DART SERVICE INSTRUCTION

TO AMEND INSTALLATION INSTRUCTIONS D350-591 REV. G
AND INSTRUCTIONS FOR CONTINUED AIRWORTHINESS ICA-D350-591 REV. 3

REF TCCA STC: SH92-6
REF FAA STC: SH967NE

A	NEW ISSUE.	JPH	10.06.08
REV.	DESCRIPTION	BY	DATE
DESIGN		DART AEROSPACE LTD	
DRAWN		HAWKESBURY, ONTARIO, CANADA	
CHECKED		DRAWING NO.	REV. A
MFG. APPR.	N/A	DSI 9525	SHEET 1 OF 4
APPROVED		TITLE	SCALE
DE APPR.		STEP CUSHION CHANGE	NTS
DATE	10.06.08	COPYRIGHT © 2010 BY DART AEROSPACE LTD THIS DOCUMENT IS PRIVATE AND CONFIDENTIAL AND IS SUPPLIED ON THE EXPRESS CONDITION THAT IT IS NOT TO BE USED FOR ANY PURPOSE OR COPIED OR COMMUNICATED TO ANY OTHER PERSON WITHOUT WRITTEN PERMISSION FROM DART AEROSPACE LTD.

FIGURE 32-9: Crosstube Attachment
REF ICA-D350-591

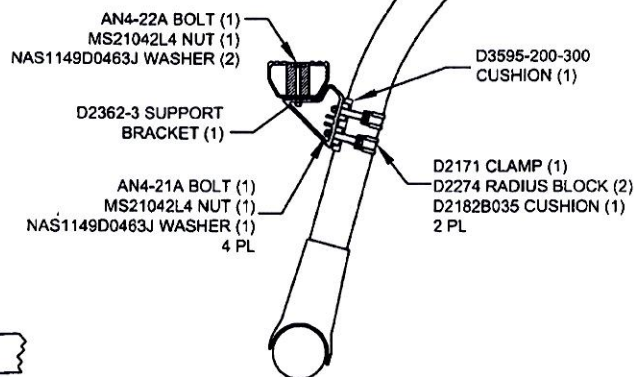
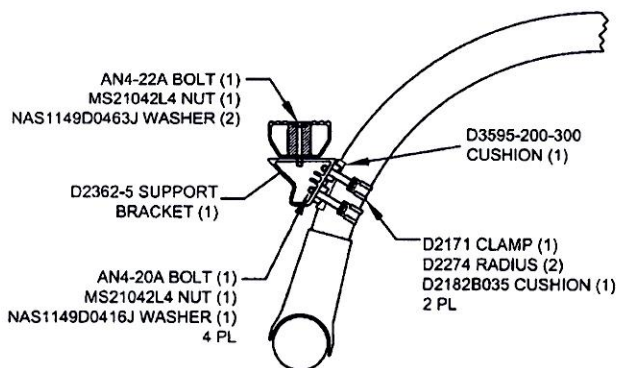
TO PROVIDE AN OPTIONAL CUSHION KIT TO BE INSTALLED ON THE D350-591-111A/-113/-115/-117A/-119 Heli-Access-Step™ (THE D2856-400-720 ABRASION STRIP IS REPLACED WITH THE D3595-200-300 CUSHION).

1. REMOVE THE STEP PER ICA-D350-591 SECTION 32.2
2. REMOVE THE D2856-400-720 ABRASION STRIP PER ICA-D350-591 SECTION 32.4
3. POSITION THE D3595-200-300 CUSHION AS INDICATED ON SHEET 3 OR 4 (AS APPLICABLE) OF THIS SERVICE INSTRUCTION.
4. REINSTALL THE STEP PER ICA-D350-591 SECTION 32.1 AS APPLICABLE USING THE NEW HARDWARE PROVIDED AS SHOWN ON SHEET 3 OR 4 (AS APPLICABLE) OF THIS SERVICE INSTRUCTION.

SECTION C-C: CENTER SUPPORT
(D350-591-111A ONLY)
(NOT TO SCALE)

SECTION D-D: AFT ATTACHMENT
(D350-591-111A/-113/-119 ONLY)
(NOT TO SCALE)

SECTION E-E: AFT ATTACHMENT
(D350-591-115 ONLY)
(NOT TO SCALE)
